ADDENDUM #2

DATE: Sept. 09, 2015

PROJECT: Rome-Floyd Health Dept. HVAC Upgrades

E3-0

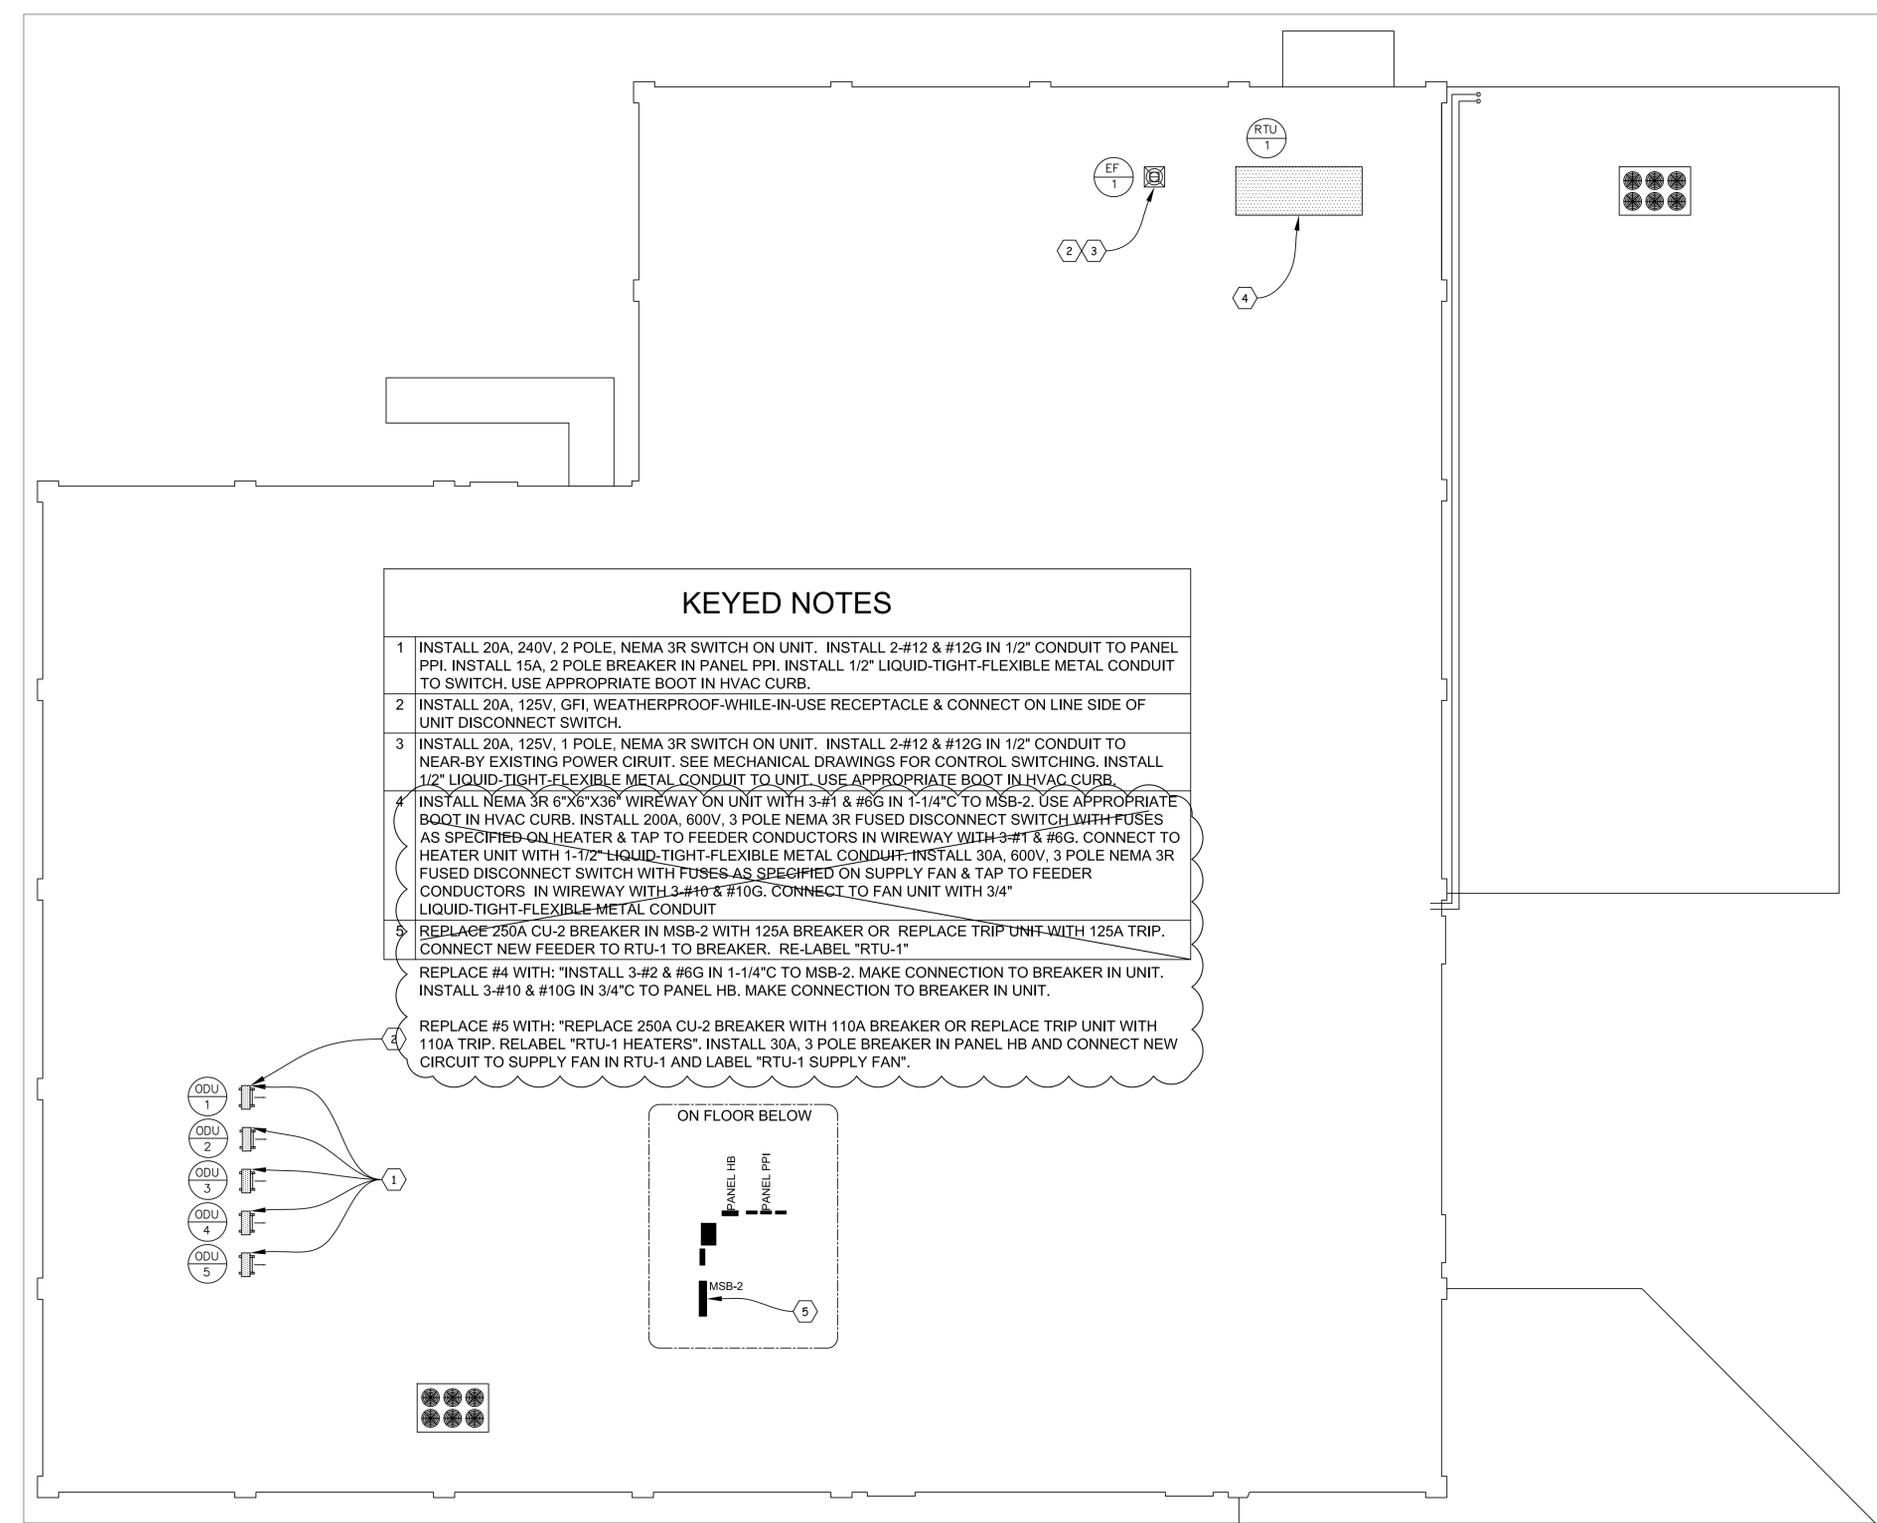
1. Replace Plan Sheet E3-0 with attached E3-0.
2. Append this sentence to specification section 15620 paragraph 2.1.B. – “Triple duty valves shall be included on the discharge of the pumps. Pump shall be manufactured by Armstrong, Taco, or Bell & Gossett.”

- REPLACE 250A CU-2 BREAKER IN MSB-2 WITH 125A BREAKER OR REPLACE TRIP UNIT WITH 125A TRIP. CONNECT NEW FEEDER TO RTU-1 TO BREAKER. RE-LABEL "RTU-1"
REPLACE #4 WITH: "INSTALL 3-#2 & #6G IN 1-1/4"C TO MSB-2. MAKE CONNECTION TO BREAKER IN UNIT. INSTALL 3-#10 & #10G IN 3/4"C TO PANEL HB. MAKE CONNECTION TO BREAKER IN UNIT.
REPLACE #5 WITH: "REPLACE 250A CU-2 BREAKER WITH 110A BREAKER OR REPLACE TRIP UNIT WITH 110A TRIP. RELABEL "RTU-1 HEATERS". INSTALL 30A, 3 POLE BREAKER IN PANEL HB AND CONNECT NEW CIRCUIT TO SUPPLY FAN IN RTU-1 AND LABEL "RTU-1 SUPPLY FAN".
